Treston Dunn  
242 Windy Farm Dr., Fuquay

Proposed 14'x14' Screened Porch

Treson Dunn  
2nd Windy Farm Dr, Fergus  
Footings

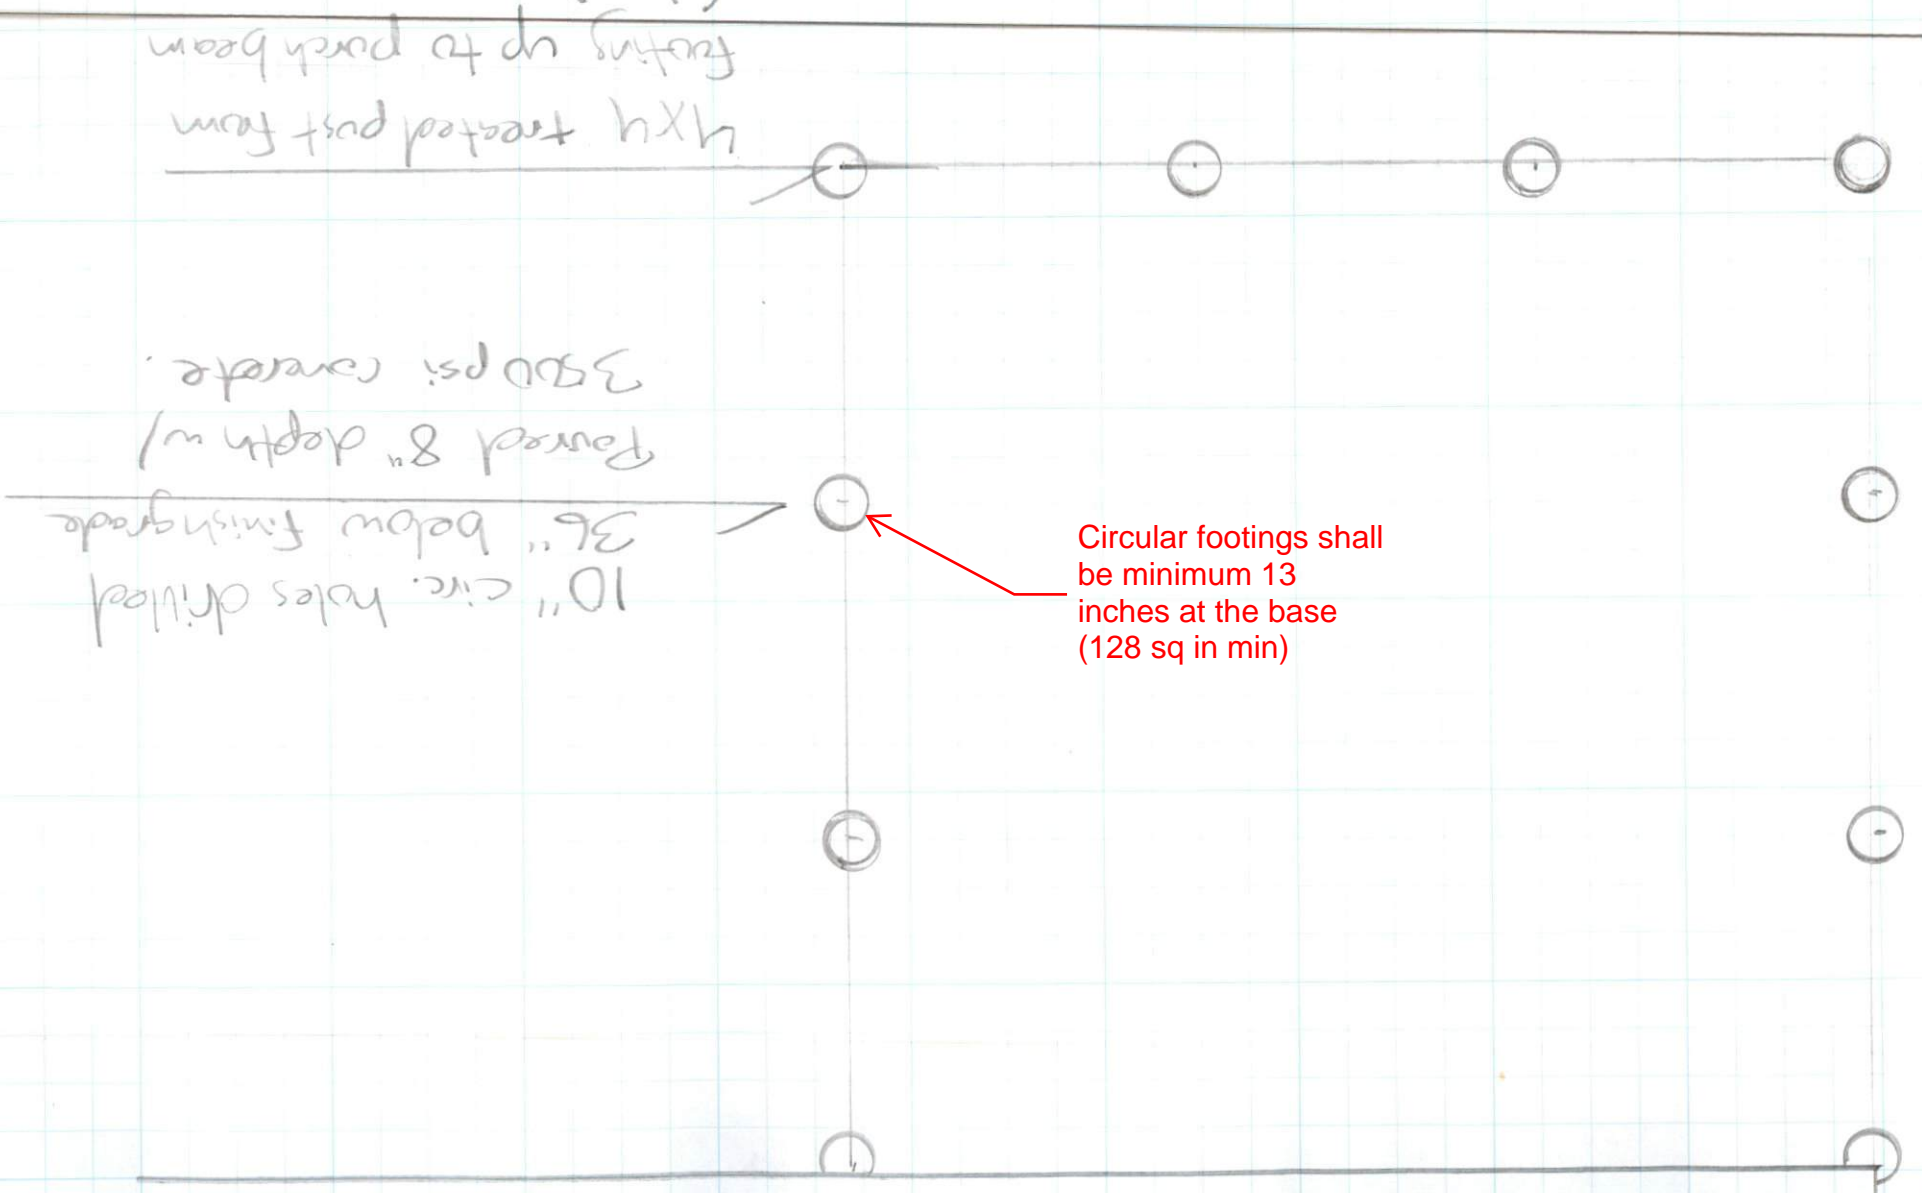
Circular footings shall  
be minimum 13  
inches at the base  
(128 sq in min)
